SERVICE BULLETIN

NO. A3312-71-2

POWER PLANT - FAN COWL - HOLD OPEN ROD
REPLACE DAMPER GUIDE ROD

FIGURE 1 - END CAP ASSEMBLY AND DAMPER

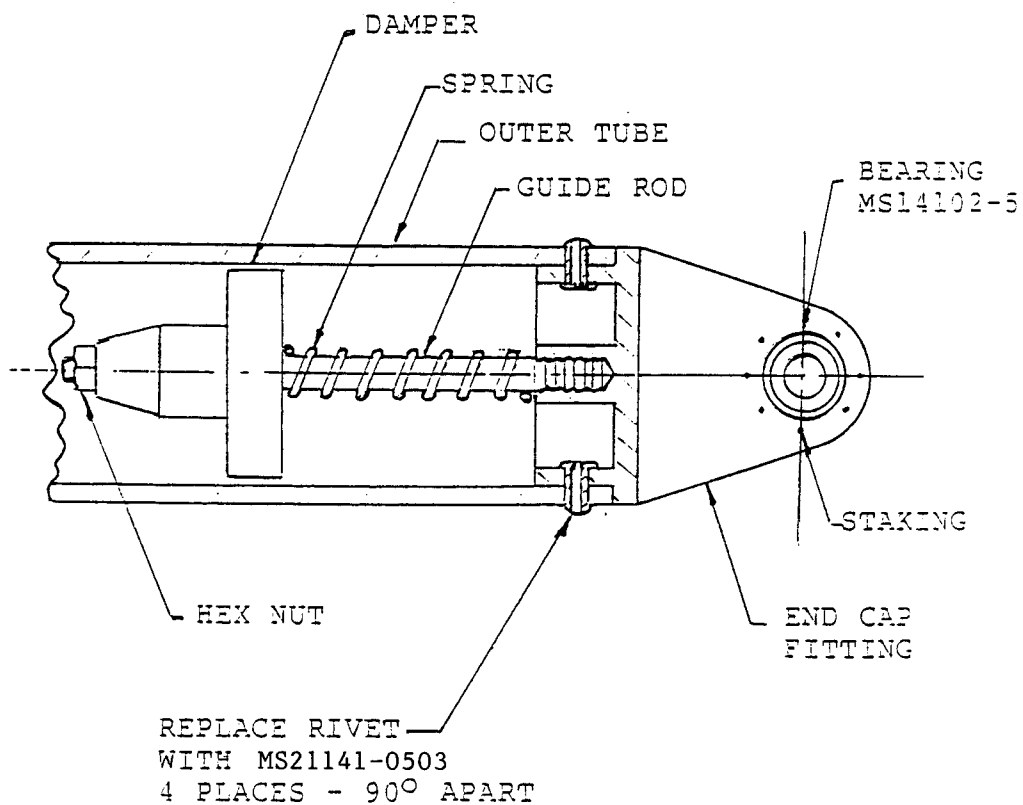
The incorporation of this Service Bulletin will prevent bending of the damper guide rod which has resulted in difficulty to fully retract the hold open rod.

This Service Bulletin provides detailed instructions required for all users to incorporate improved guide rod assembly in Norco P/N A3312-2, Rohr P/N 277D1250-503. This procedure consists of removing the four (4) rivets in the rear end of the outer tube and replacing the damper guide rod and end cap with new end cap assembly, AM3312-2-50. The reworked rod will be reidentified as Norco P/N A3312-3, and Rohr P/N 277D1250-505.

- C. Drill out four (4) rivets in outer tube, shown in Figure 1, using a No. 19 drill, .166 inch (4.216 mm) diameter. Center drill point in center of rivet. Drill only deep enough until rivet head separates from stem. Tap remaining rivet into outer tube.

- D. Remove end cap assembly from end of outer tube. Remove hex nut, damper, and spring from guide rod and save for use in new end cap assembly.
- E. Remove spherical bearing, MS14102-5, from end cap assembly by pressing out. Press bearing into new end cap assembly, AM3312-2-50, and stake at 8 points equally spaced around both sides of the bearing housing. The staking tool should have a spherical radius of .093 - .108 inches (2.362 - 2.743 mm) and produce a .010 - .015 inch (.254 - .381 mm) indentation located .050 - .060 inches (1.270 - 1.524 mm) from the O.D. of the bearing.

- F. Insert end cap assembly into end of outer tube and align rivet holes with pilot holes in end cap assembly. Drill out holes in end cap assembly using a No. 19 drill .166 inch (4.216 mm) diameter and holes in outer tube as pilot holes.

- I. Place spring and damper on guide rod of end cap assembly. Apply Loctite No. 640, or equivalent, to threads of guide rod and screw on hex nut. Torque to 10 in. lbs.

- J. Place end cap assembly back into end of outer tube and align rivet holes using marks placed on outer tube and end cap assembly.
- K. Apply primer TT-P-1757 and install four (4) MS21141-0503 rivets using a double action tool as indicated in Military Standard MS21141.
